DECISION OF THE ENDURANCE COMMITTEE

To: ☒ Teams ☒ Manufacturers
Category: ☒ LM P1 ☐ LM P2 ☐ LM GTE Pro ☐ LM GTE Am
Decision N°: **17-D0042-LMP1NH**
Date: **28/11/2017**
Re: Clarification for the front diveplanes

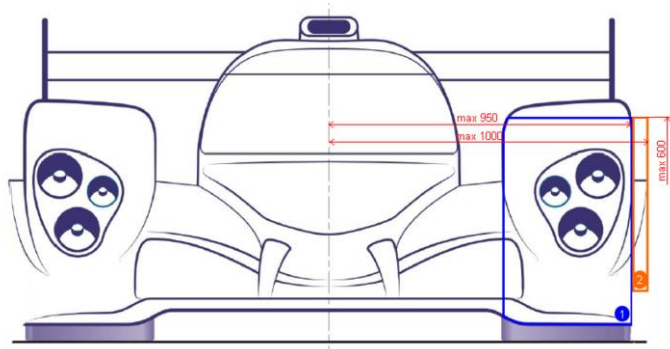
Further to different questions from LMP1NH chassis constructors, FIA/ACO would like to clarify the situation regarding the front diveplanes. In Technical Regulations, two articles (Art.3.5.4.a and Art.3.6.1) are referring to them:

- ① (as shown on the following picture) is defined inboard/outboard by the frontal projection of the wheel arch;
- In frontal projection of the wheel arch ①, respecting the conditions of Art.3.6.1, **a maximum of two pairs of diveplanes is allowed (lower than Z600).**

- ②, defined by outboard frontal projection of front wheel arch and Y1000;
- Between X-400 and X-900, and between Z100 and Z600
- Respecting the conditions of Art.3.5.4.a, **more than 2 pairs of diveplanes are allowed**

The diveplanes in ① and ② should be physically different parts, however they can be linked together.
FIA/ACO recommend chassis constructors to submit CAD drawing to validate designs.
